LLFA COMMENT / QUERY TRACKER - 11.02.2020

This tracker has been compiled to provide a detailed response to comments received by Camden Planning from the Lead Local Flood Authority in relation to the proposed development.

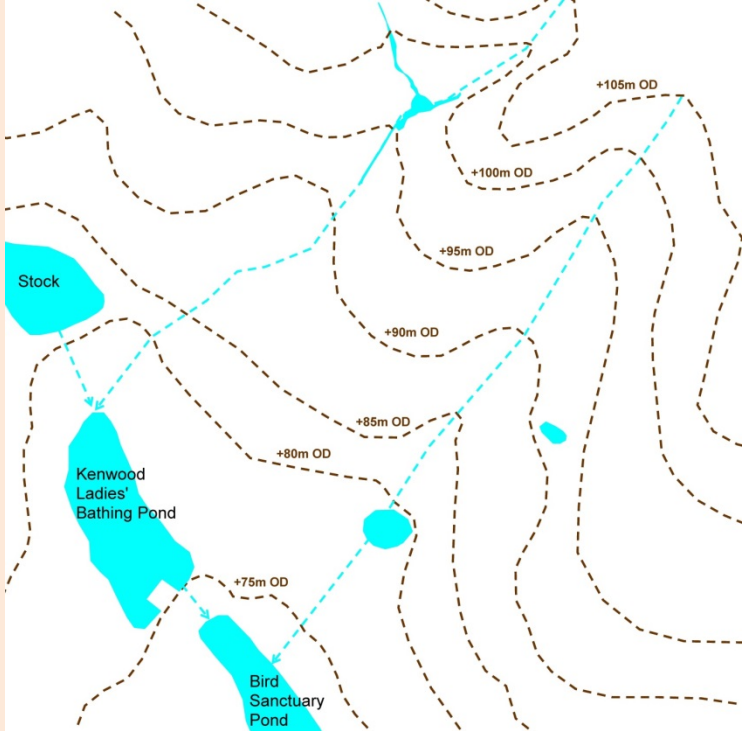
LLFA 2ND COMMENTS 04/10/2019	APPLICANT RESPONSE 24/10/2019	LLFA 3RD COMMENTS 08/11/2019	APPLICANT RESPONSE 11/12/2019
<p>Plan shows:</p> <ul style="list-style-type: none"> 50 m³ surface water attenuation 15 m³ swale 3 m³ underground attenuation tank Flow controlled rate from driveway 5 l/s <p>Issue i: the indicated storage adds to 68 m³, a shortfall of 73.5 m³.</p> <p>Issue ii: No technical details indicated for the blue-green roofs (storage volume, area/depth, void %, flow controls, discharge rates etc.)</p> <p>Issue iii: no information on freeboard requirements</p>	<p>Issue i: There is a total storage volume of approximately of 141.5m³, which is made up as follows:</p> <ul style="list-style-type: none"> 15m³ in the swale 50m³ in the attenuation tank 76m³ in green and blue roof storage <p>Issue ii: The green/blue roofs will be designed by a specialist supplier/designer and it is unreasonable to request such details at this time as any specialist supplier/designer is unlikely to carry out a design without first receiving an order and deposit.</p> <p>Issue iii: The proposed house levels for the houses on the east side of the site are in excess of 1m above the level of Millfield Lane. From this it is clear there is more than ample freeboard provided.</p>	<p>Issue i: Noted. The blue-green roof storage information the Drainage Report. At least the Site Drainage Layout should be updated with the figures that make up the 76 m³. Further action requested</p> <p>Issue ii: Adequate information should be submitted at planning stage, based on outline designs generated by the drainage consultant. This is to show the LPA/LLFA how the proposed drainage measures, rates and volumes could be achieved in the scheme. Final detailed design information is not expected at this stage; it is accepted details may change, but the potential to achieve the stated aims should be demonstrated. Further action requested</p> <p>Issue iii: This request related to the SuDS freeboards as per original comment: "Provide the maximum volume each of the SuDS features can accommodate, as well as freeboard requirements in order to verify if the 141.5 m³ of attenuation required can be accommodated and indicate the discharge rate from the impermeable driveway to the combined sewer. Further action requested</p>	<p>Issue i: The roof designs will be undertaken by a specialist designer in due course.</p> <p>At this stage a conservative assumption might be made as follows:</p> <p>Assumed Approx. green/blue roof area</p> <p>Plots 1 to 3 - 80 m² each Plots 4 & 5 - 135 m² each Assumed equivalent depth water retained 150mm (3 x 80) + (2 x 135) = 510 m² 510 m² x .15m = 76.5 m³</p> <p>NB. Coyle Kennedy have provided a further assessment (attached) based upon revised areas that suggests 125m³ of blue/green roof storage to be potentially available.</p> <p>Issue ii: Coyle Kennedy have provided additional information (attached) to demonstrate how the drainage measures will be achieved.</p> <p>Issue iii: Coyle Kennedy have indicated a surplus storage capacity of some 50m³. Given that there is no potential for freeboard within the filled swale and the attenuation tank this can be accommodated within the roof designs as a freeboard of some 60mm. (see attached CK detail)</p>

Pond Catchment Area (based upon Lidar)

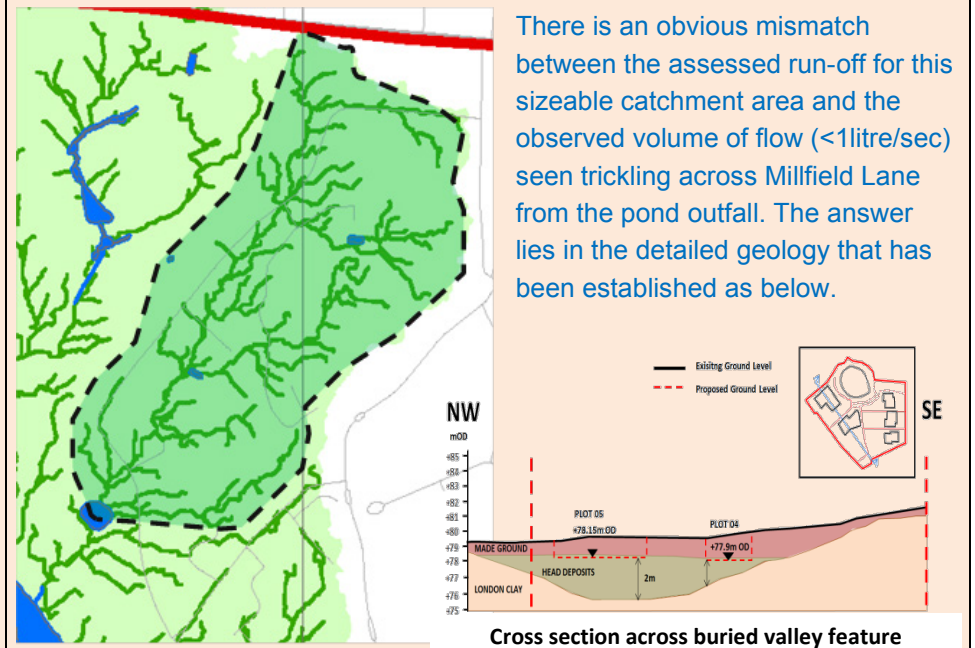
<p>Issue 1:</p>	<p>Comment:</p> <ul style="list-style-type: none"> - The information within the <i>Response to Further Information request</i> indicates the total storage volume of the swales, the attenuation tank and the green and blue roof to be 141m³. - The <i>Drainage Report</i> indicates the drainage strategy for the development will comprise of discharging runoff from the “paved carparking & roads areas & discharging to the combined sewer running beneath Fitzroy Park via attenuation”. The drainage plan (<i>Drawing No. P300 Rev B</i>) shows a 3m³ attenuation tank connecting to MH S5. The Asset MH S5 is a Hydro-brake flow control manhole restricting flows to 5l/s. It is assumed the attenuation tank is designed as offline storage for this section of the drainage network as the drainage plan shows no online connections draining to the tank. The storage provided by this attenuation tank is not mentioned in the proposed attenuation storage stated in the <i>Response to Further Information request</i>. - The <i>Drainage Report</i> also indicates the drainage strategy for the “blue/green roofs, paved areas & footpaths” will discharge “through the attenuation / swale via percolation”. An overflow pipe is proposed to discharge excess flows from the attenuation to the Heath. - Furthermore, the Figure (no label) in the <i>Addendum to BIA Submission</i> report shows the location proposed for infiltration to be underlain by London clay which lies at approximately 80.5 mAOD. The ground level shown in the Figure indicates the ground level to be 81.2 mAOD. The report presents groundwater monitoring results from September 2017 and November 2018 investigations. The highest groundwater level, with respect to ground level, were record 80.14 mAOD 	<p>The LLFA comments of 15th January do not reflect what was presented and discussed at the meeting of 26th November.</p> <p>It is necessary to right back to the initial hydrological & hydrogeological impact assessment report and to understand that this site substantially comprises a parcel of land with a watercourse running through it. Over the ages, that watercourse has become largely hidden but it is still there, feeding the pond and in turn the Heath Nature Reserve and the Bird Sanctuary.</p> <div style="text-align: center;">  </div> <p>It has been recognised from the very outset of the project that the potential</p>

in September 2017 and 80.05 mAOD in November 2018. These values are equivalent to 0.66m below ground level (bgl) and 0.75m bgl respectively. If infiltration is feasible, it would not be compliant with guidance within the SuDS Manual.

- The borehole records for BH2, found in the *Site Investigation Report*, show Clay was encountered up to a depth of 30m.
- No infiltration rates and calculations for the infiltrations SuDS are provided in the information submitted, therefore it is not possible to assess the SuDS against the design standard (i.e. the 1 in 100 year plus Climate Change event).

- The drainage layouts (*Drawing No. P-300 Rev B and Drawing No. P-301 Rev A*) indicate that the swales lie outside the site boundary.
- The drainage network sections plan (*Drawing No. P-302*) indicates the invert level (IL) of the foul network at the outfall to the combined sewer to be 82.101 m AOD and the IL of the surface water network at the outfall to combined sewer network to be 81.145 m AOD. However, the IL of the existing Thames Water sewer has not been provided. Thames Water asset plans are provided in the *Addendum to BIA Submission* report, however the asset information for the proposed connection point is not within the asset search boundary.

impacts of development could affect not only the development itself, but also neighbouring properties and the wider neighbourhood, including the important wildlife habitats of the Hampstead Heath nature reserve and more specifically the Highgate Ponds, which lie a short distance below the site. It is not a matter of requesting permission from the CoL for the watercourse to be allowed to continue to discharge into the nature reserve. Conversely, it is absolutely essential that it should continue to do so.

There is an obvious mismatch between the assessed run-off for this sizeable catchment area and the observed volume of flow (<1litre/sec) seen trickling across Millfield Lane from the pond outfall. The answer lies in the detailed geology that has been established as below.
